[Docket No. FAA–2013–0725; Directorate Identifier 98–CE–01–AD; Amendment 39–17690; AD 98–15–18 R1]

Airworthiness Directives; Maule Aerospace Technology, Inc. Airplanes

ACTION: Final rule.

98–15–18 R1 Maule Aerospace Technology, Inc.: Amendment 39–17690; Docket No.

Figure 1

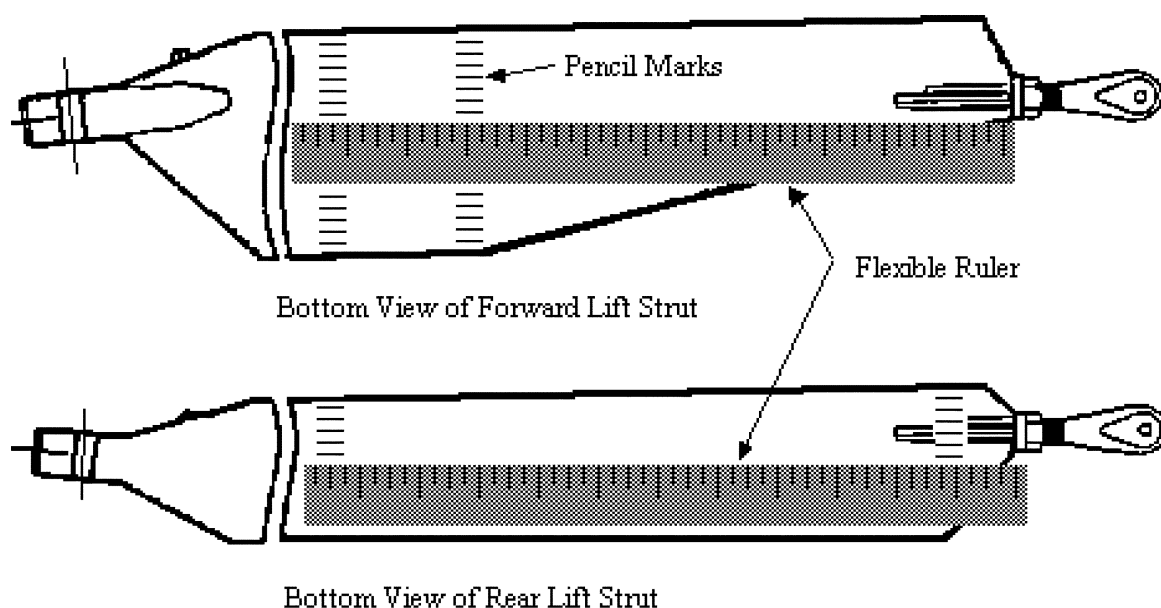
2. Using a flexible ruler, draw a 1/4-inch grid on the surface of the first 11 inches from the lower end of the strut as shown in Maule Air, Inc. Service Bulletin No. 11, dated October 30, 1995, as applicable. This can be done using a soft (#2) pencil and should be done on both faces of the strut. As an alternative to drawing a complete grid, make two rows of marks spaced every 1/4 inch across the width of the strut. One row of marks should be about 11 inches from the lower end of the strut, and the second row

should be several inches away where the strut starts to narrow. Lay the flexible ruler between respective tick marks of the two rows and use tape or a rubber band to keep the ruler in place. See Figure 1.
